Re:
1320 Hollywood Blvd
Hollywood, Florida 33019
Architect's Project #25075

DUBEY HISTORIC RESIDENCE
 1320 HOLLYWOOD BLVD
 HOLLYWOOD FLORIDA 33019

PLANNING COMMENTS | URJA MODI | umodi@hollywoodfl.org

Plan Description: EROSION CONTROL PLAN

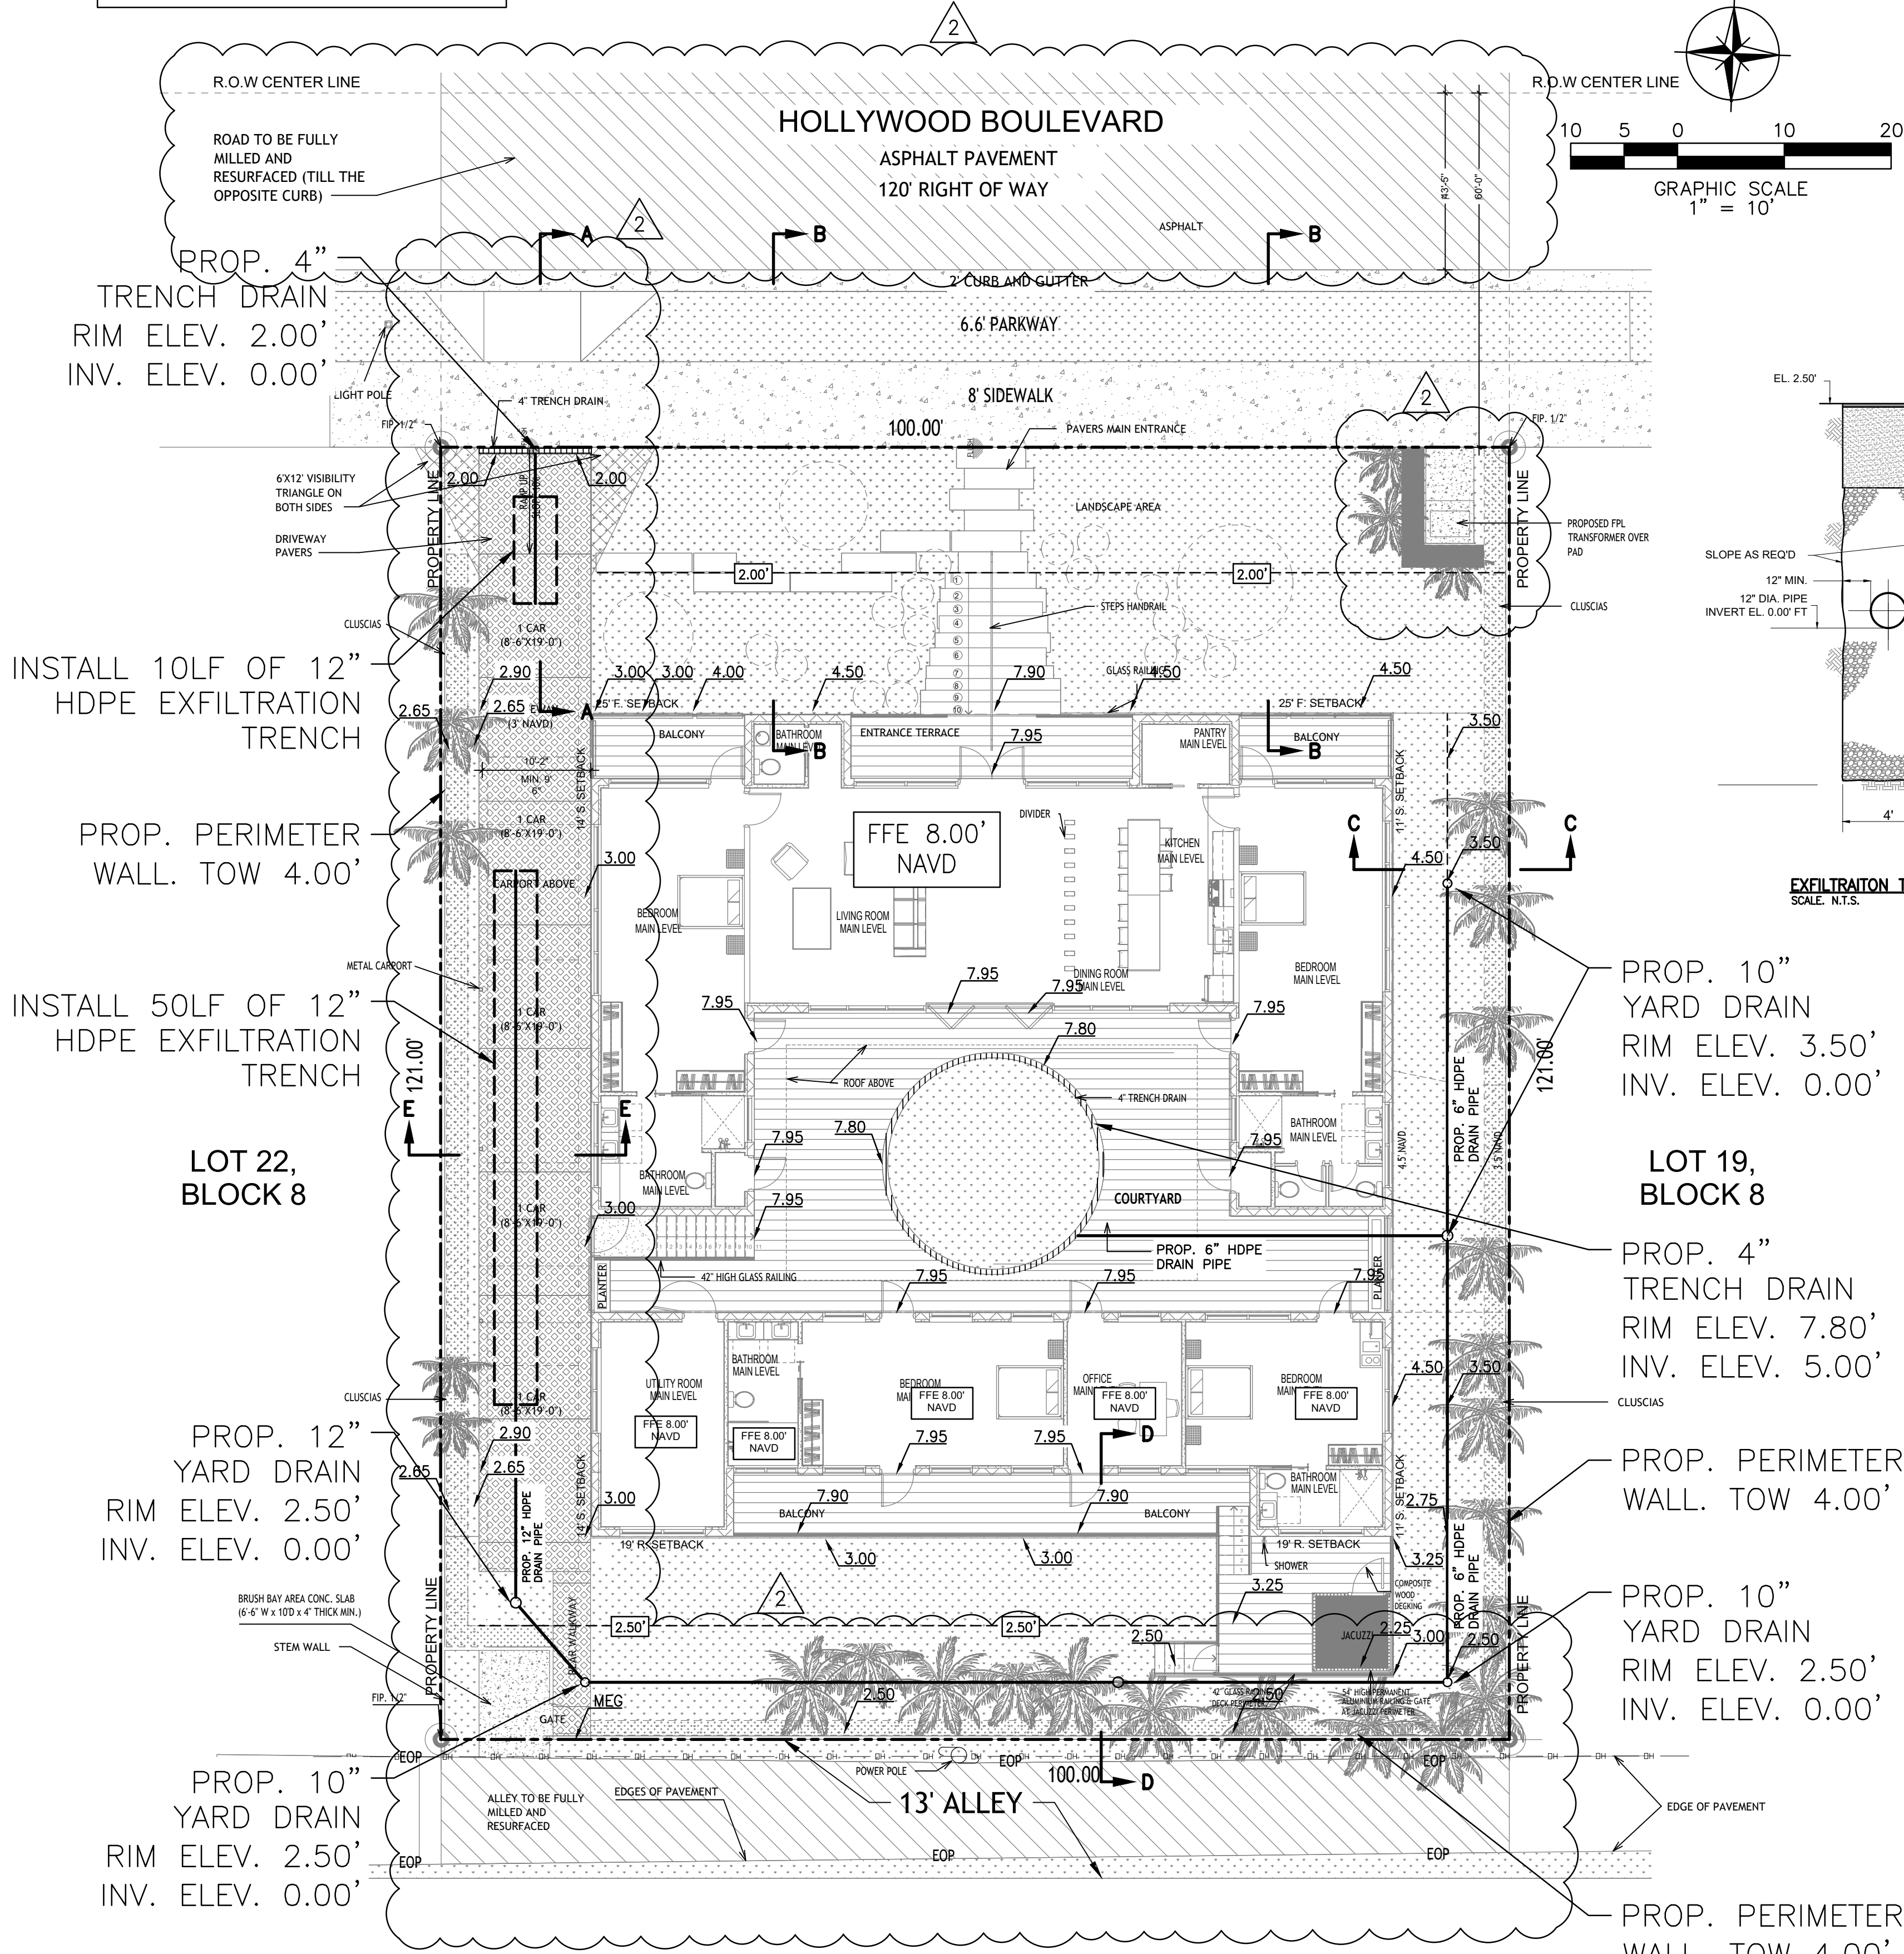
A. Sheet C-02 – Temporary Construction Entrance does not align with existing driveway apron and curb cut.

RESPONSE: Temporary Construction Entrance now matching. REF: Sheet C-02.
